ADMINISTRATIVE DECISION

Hillside Development and Significant Environmental Concern Permits
Case File No.: HDP 10-97 & SEC 18-97
(August 28, 1997)

WHAT: An application for a Hillside Development Permit for the purposes of placing approximately 80,000 cubic yards of imported silt, sand and gravel over a 3 to 5 year period. The fill embankment is to be returned to grass covered pasture or forest land after the fill is complete. No structures or impervious surface is planned for the area.

Denial of Hillside Development Permit No. 10-97 and Significant Environmental Concern Permit No. 18-97 for the purposes of filling a 22 acre area with approximately 80,000 cubic yards of imported silt, sand and gravel material.

Site Plan, Figure 2
Fred Hall Property
23425 NW Moreland Road
Portland, Oregon

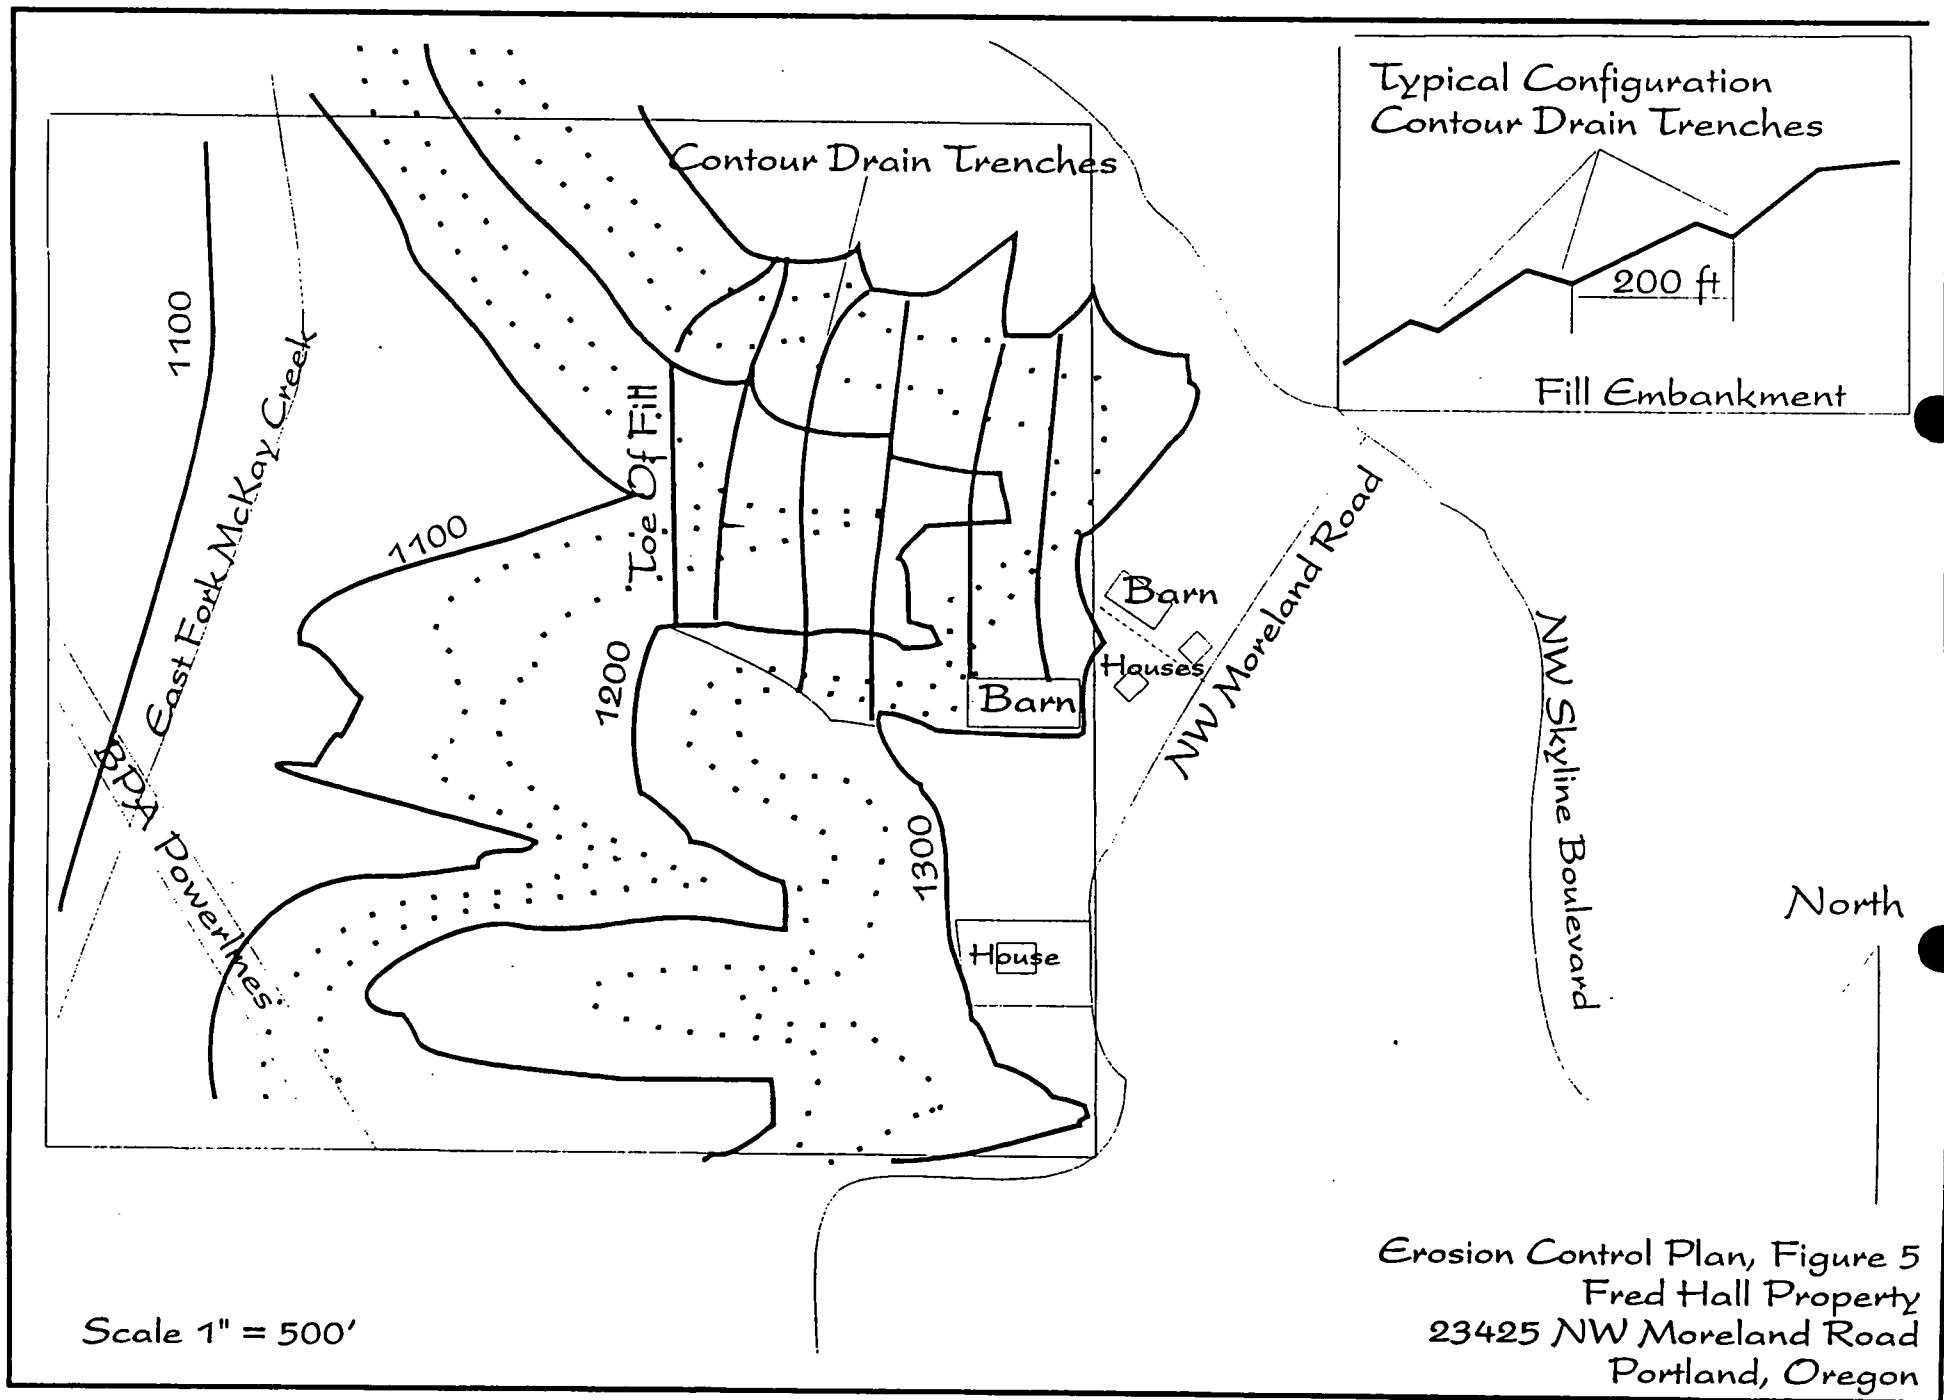
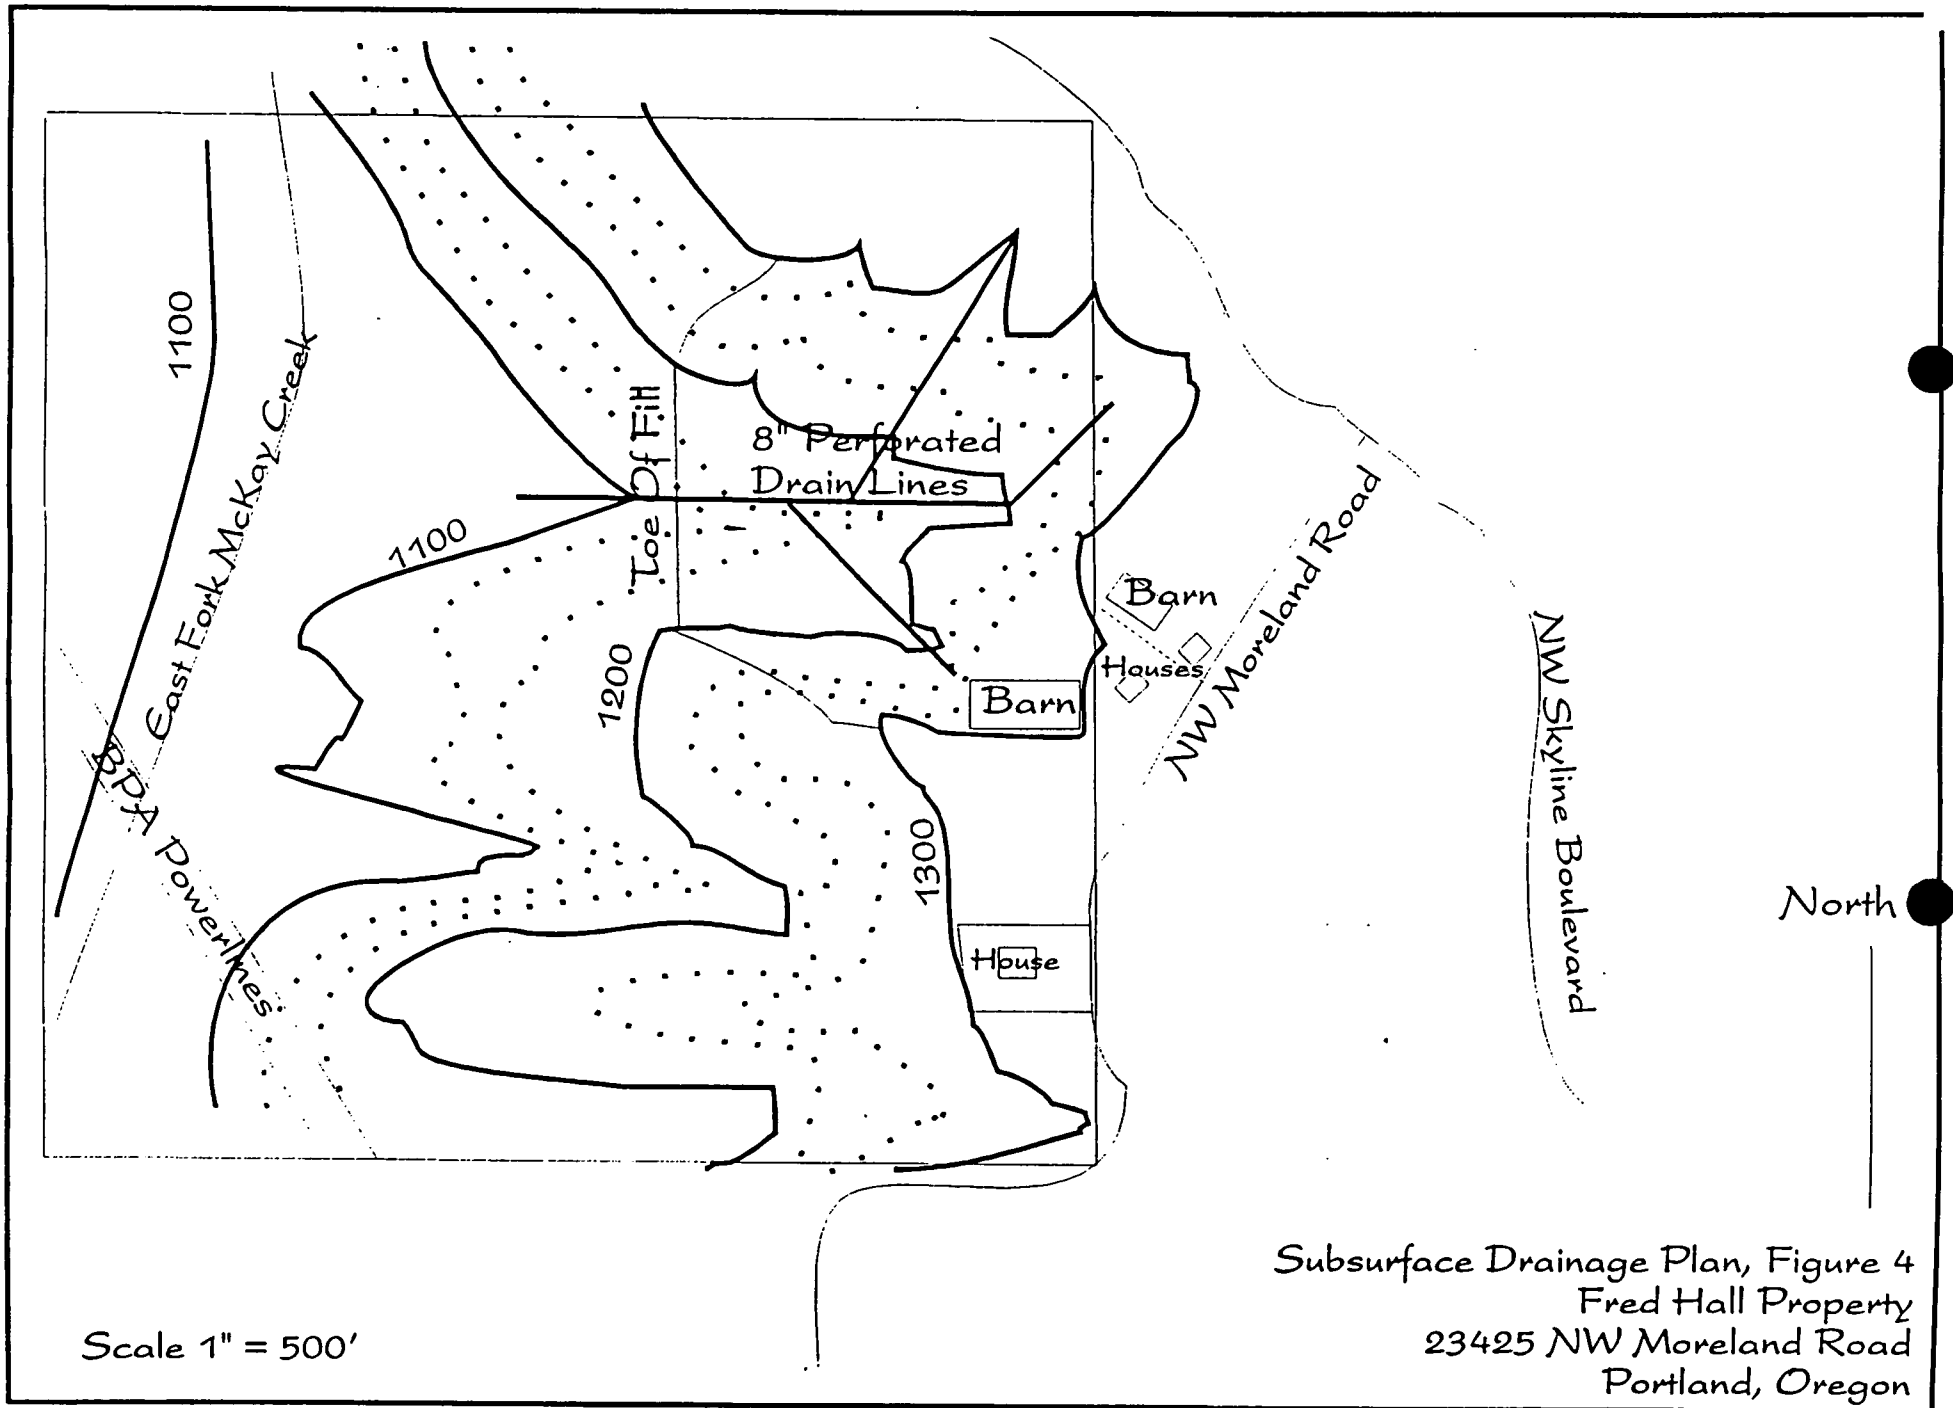
Staff: The drainfields are shown on Figure 2 of the Geotechnical Report.

Grading Plan, Figure 3
Fred Hall Property
23425 NW Moreland Road
Portland, Oregon

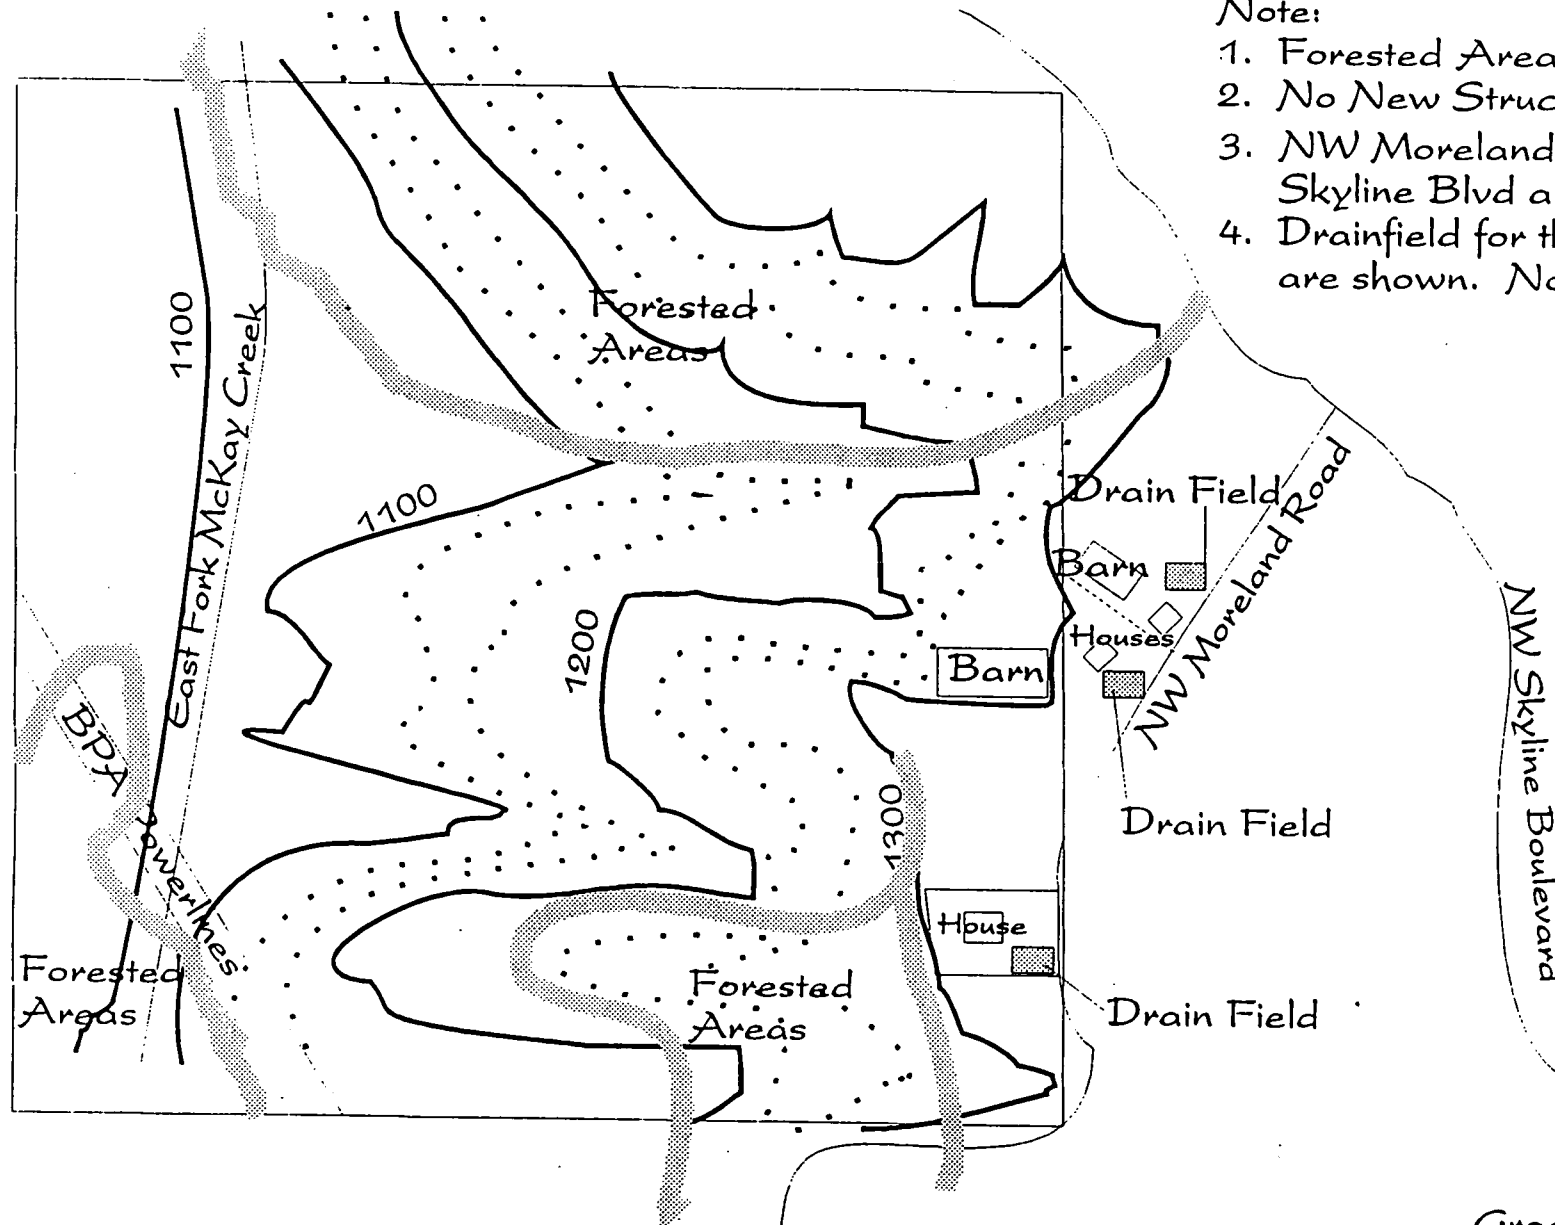
Staff: The application materials submitted do not appear to accurately depict the proposed fill project. Topographic contours are shown at an interval of 33-1/2 ft and may be an interpretation of the contours, as staff is not aware of any published resource materials that would utilize that interval. The applicant has not indicated that a survey was completed or submitted a copy of a survey by a registered land surveyor or registered engineer. In addition, MCC requires that topographic information be represented on a map with a contour interval not to exceed 10 feet. The cross-sections and narratives do not correspond and call into question the actual depth of the fill. No effort has been made to minimize the fill operation. It is questionable that any fill operation is necessary since the site is currently being used for pasture and forest operations and that is what is proposed for after the fill completion. The applicant has not suggested or discussed what improvements the fill will have on the farm/ forest operation. No structures are proposed. This criteria has not been demonstrated to be met.

Staff: A portion of the fill area will occur in currently forested land (Figure 3, SEC report). From the above statement, staff must assume that the trees will be cleared from this area. No boundaries for tree removal have been indicated.

East - West Cross-Section A'-A, Figure 8
Fred Hall Property
23425 NW Moreland Road
Portland, Oregon

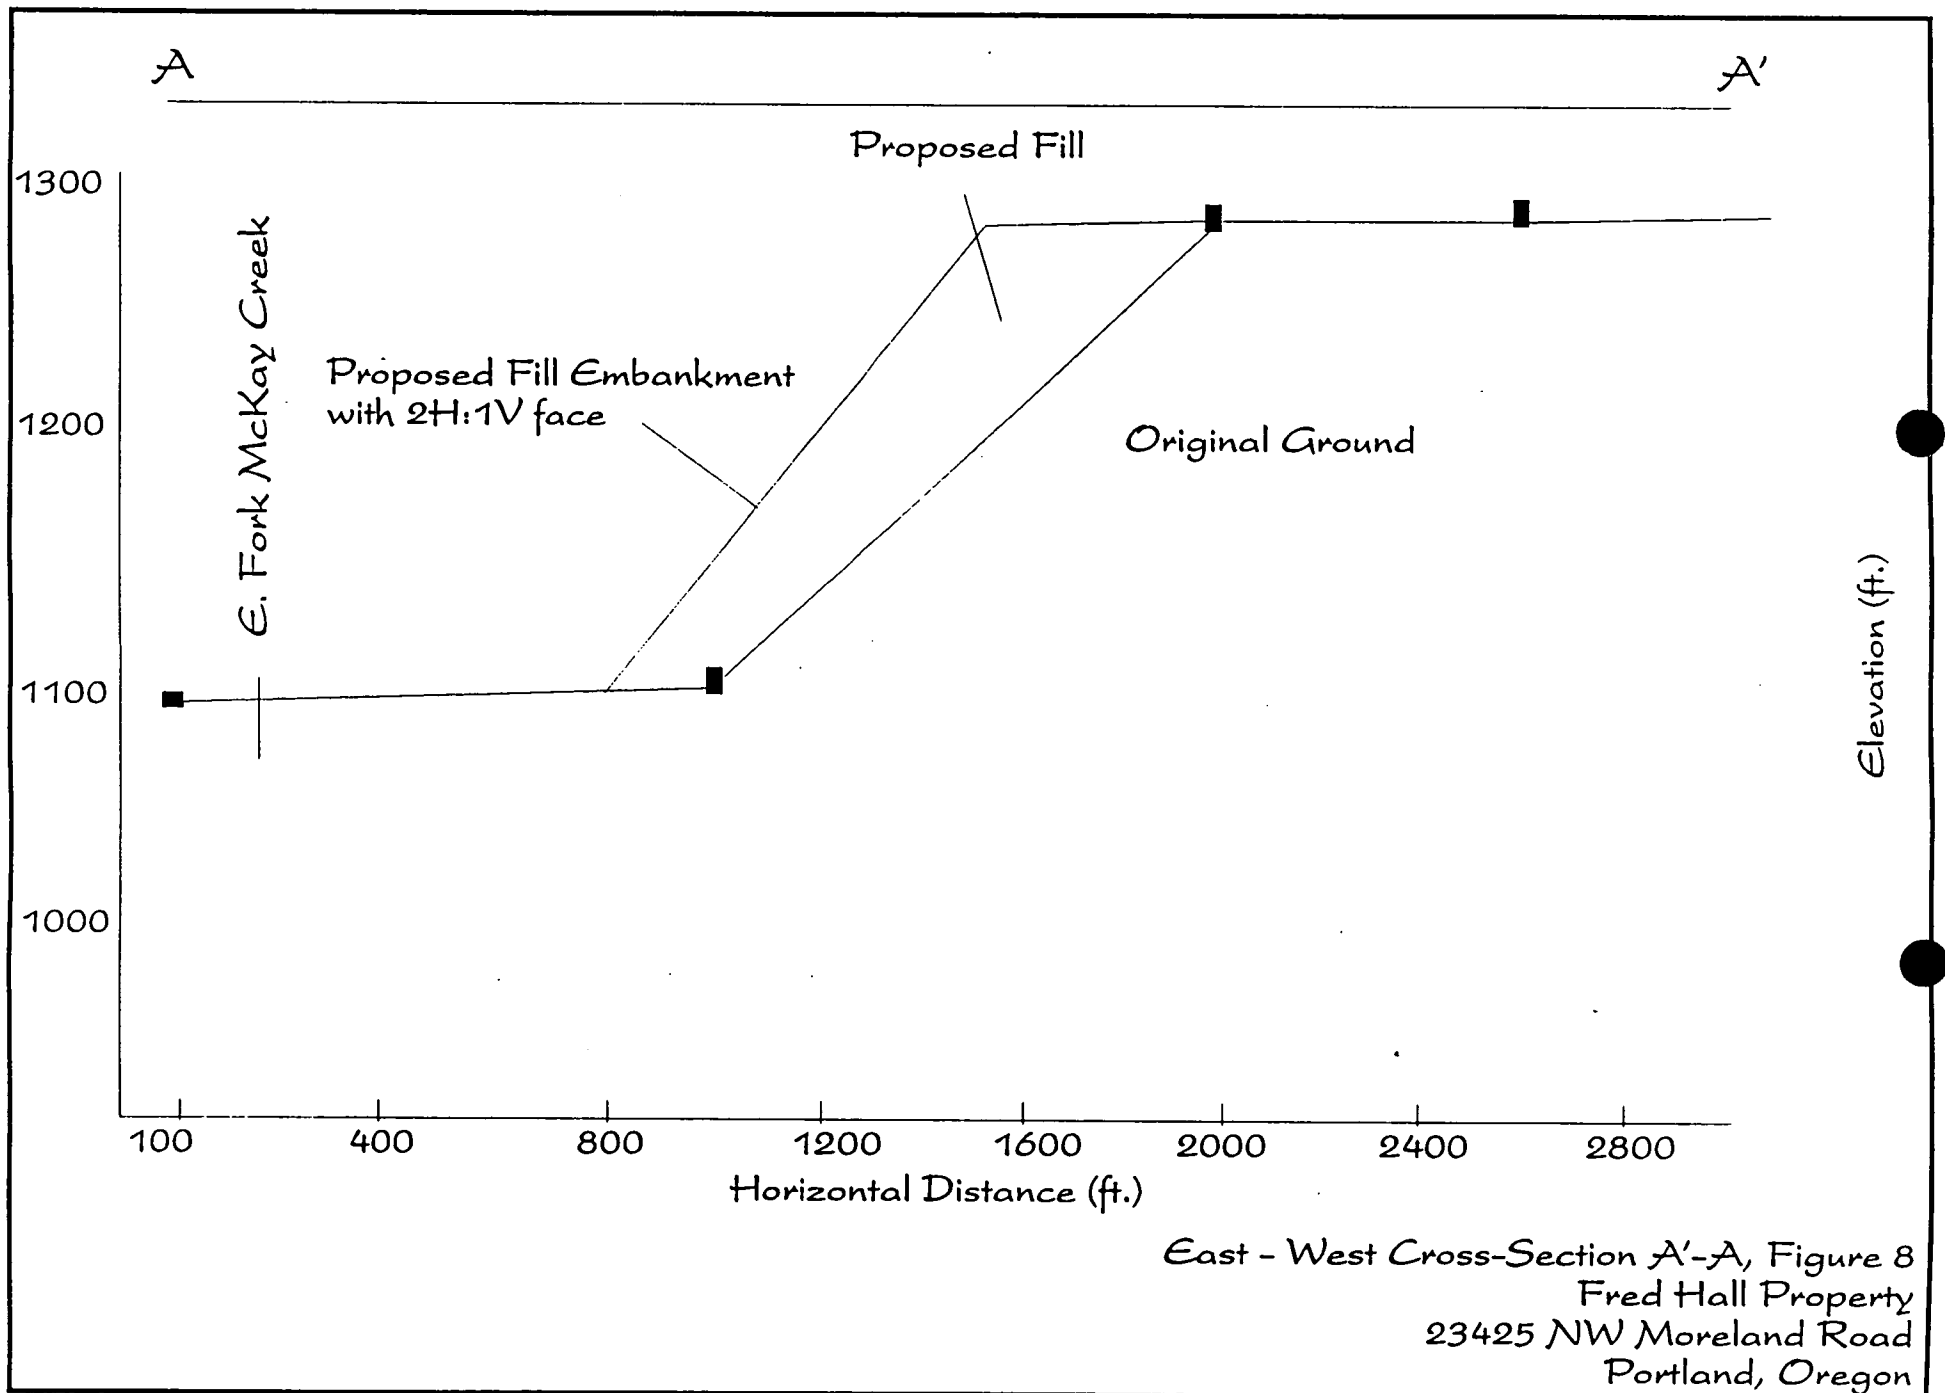
Staff: Two cross sections and two benching details has been submitted with this application. These cross sections are not to scale and conflict with each other. Cross section A - A' shows the fill will be approximately 200 feet deep. Cross section B -B' shows the fill will be approximately 100 feet deep and the narrative statement state it will be a maximum thickness of approximately 40 feet deep. Staff requested that the applicant modify the site plan to clearly show the boundary area of the proposed fill and to provide 1 cross section per 50 ft of project area. In addition, a profile is needed. Topographical information supplied has established the contour interval at 33-1/2 ft, which is inadequate and does not comply with Code requirement for it not to exceed 10 ft elevation change per contour. The applicant indicated on August 7, 1997 that no additional information shall be provided.

Staff: Cross section A-A', Figure 8 indicates that the proposed fill embankment will have a 2H:1V face. The above statements from the Geotechnical Report indicates a slope stability of 1.5. The analysis of the current site configuration or completed fill configuration which was indicated above in the applicants answer was not attached to the geotechnical report submitted for engineering review. Without this information, staff is unable to verify the above conclusionary statements that the slopes are safe to 1.5 H :1 V.
